## AW5015DNR Added A Bonding Wire Notice

PCN No.	20180615002	PCN Date	2018/06/15
Item	AW5015DNR added a bonding wire notice		
Contacts	Scott Zhang	Phone	+86-21-54271166 #6899
		Dept.	QA
PCN Form			
<input type="checkbox"/>	Wafer material	<input type="checkbox"/>	Wafer technology
<input type="checkbox"/>	Assembly material	<input checked="" type="checkbox"/>	Assembly technology
<input type="checkbox"/>	Design	<input type="checkbox"/>	Testing process
<input type="checkbox"/>	Electrical properties	<input type="checkbox"/>	Packaging/Label/Logistics
<input type="checkbox"/>	Production-line expanded	<input type="checkbox"/>	Others:
<input type="checkbox"/>		<input type="checkbox"/>	
Sample			
<input checked="" type="checkbox"/>	Can be offered		
<input type="checkbox"/>	No needed		
<input type="checkbox"/>	Can be offered soon	Estimated offered date

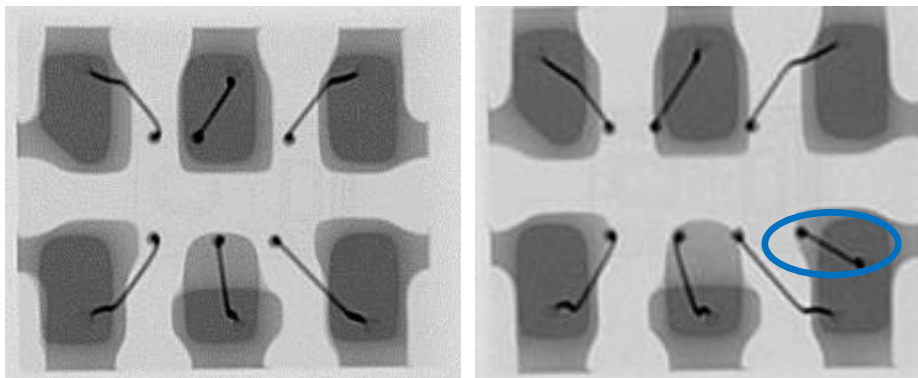
AW5015DNR added a bonding wire, The specific change is as follows:

Add a wire marked by a blue circle, this wire is to connect GND with RFGND.

Add a wire to connect GND with RFGND, improve product consistency

This change does not affect the function, performance and application of the product. Both products can be used.
